Addendum 53 – UN Regulation No. 54

Revision 3 - Amendment 6

Supplement 24 to the original version of the Regulation – Date of entry into force:
30 September 2021

Uniform provisions concerning the approval of pneumatic tyres for commercial vehicles and their trailers

Figure, amend to read:

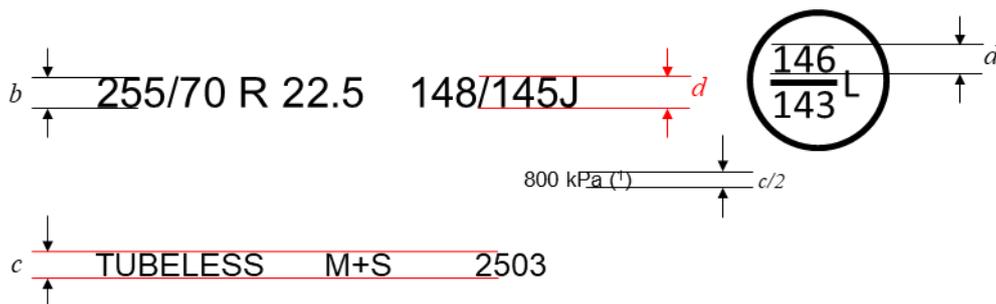
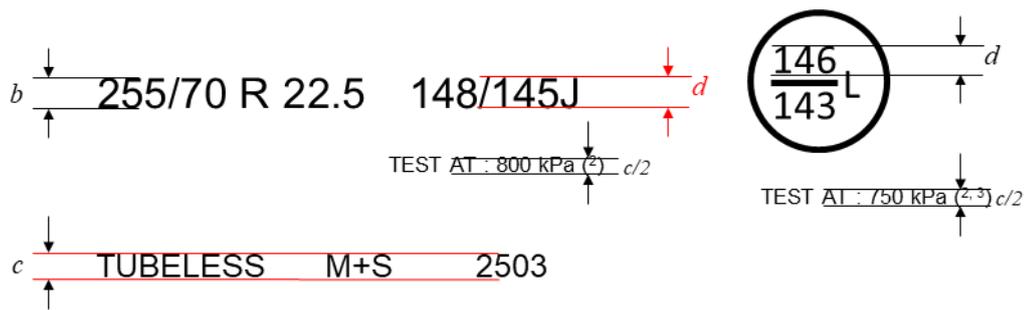
"Example 1:

(1) PSI marking instead of kPa is allowed for tyres first type approved before 1 January 2018. The kPa marking may be preceded by "TEST AT : " or, alternatively, by "TEST INFL : " or the symbol "@".

Example 2:

- (²) "TEST AT : " may be replaced by "TEST INFL : " or the symbol "@" or be omitted.
- (³) The indication of a second inflation pressure for the additional service description is optional. If there is no indication, the same test inflation applies to both load/speed combinations.

Dimensional requirements for further markings (⁴):

- (⁴) For "ML" and "MPT" being part of the tyre size designation marking the minimum dimension *b* applies."
